BULLETIN N° 90

New design TA and T pumps

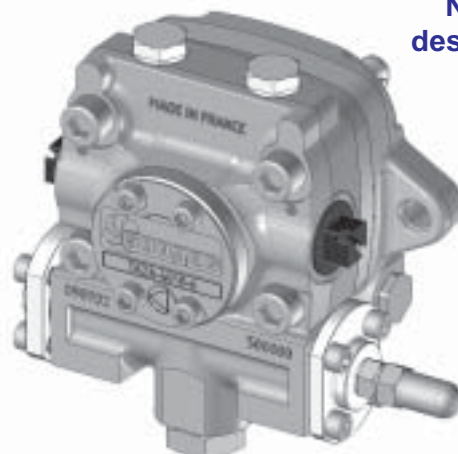
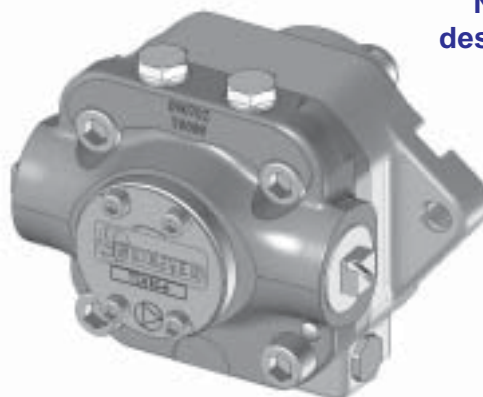
To improve the quality of TA and T pump range, SUNTEC invested in a new 4 axis CNC machining center.

This new production tool will allow us greater flexibility and precision. The manufacturing process will be optimized.

As this new machining center requires new forms of foundry, the external appearance of our TA and T pumps will be slightly modified. The mounting of the pump, the position and dimensions of fittings for inlet and return do not change, the pumps are fully compatible with the existing burners.

To identify this new design, the serial numbers of these pumps will be incremented from 500 000 (for TA pumps) and 50 000 (for T pumps) and the references of these pumps will have a **new revision number : revision 7**.

The designation of these new pumps will be as follows :

TA 3C 4010 **7**, TA4 A 4010 **7**, ... for TA models
T3C 107, T5A 107, ... for T models.
